### Service Bulletin

No. : MZ05-036

**Model:** SR9600

**Subject:** The Backup Transformer Fuse opens.

**Change part**

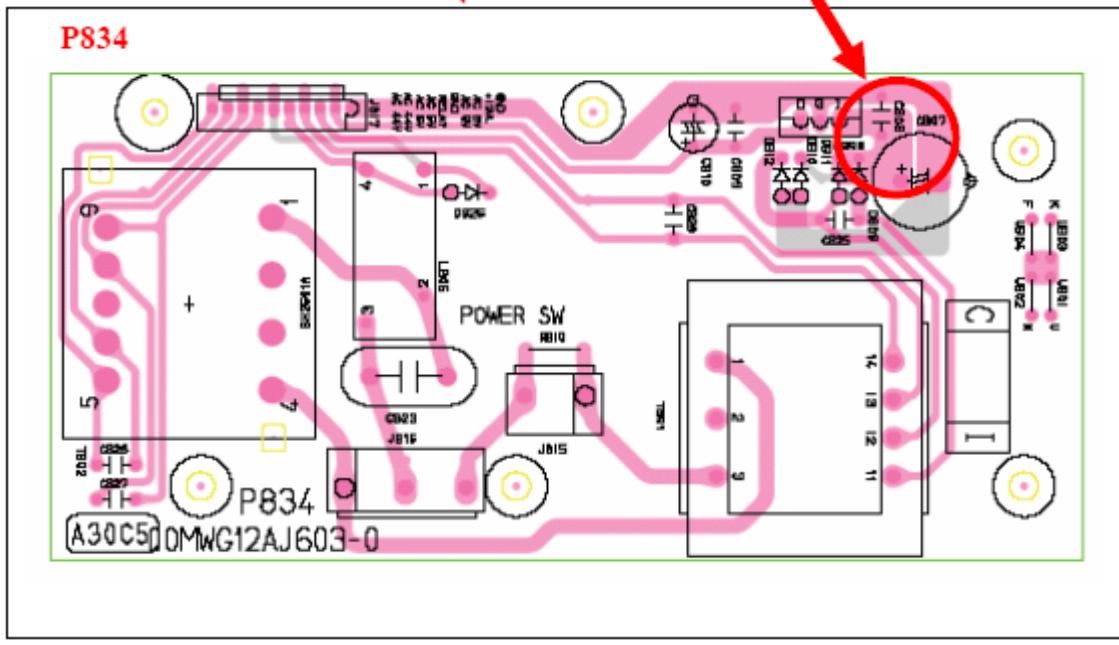
**Symptom:** This problem (open fuse) can occur when an unsuitable cable (mono plug) is connected to IR-RECEIVER IN Terminal (Stereo mini plug). If the terminal short-circuits from an unsuitable cable, there is a possibility of opening the fuse for the Backup Transformer (TB01) due to over current.

**Solution:** Add a Circuit protector (Polyswitch) and Cut the pattern on the P834 FLD/BACKUP TRANSF PWB. See the attached pictures for details.
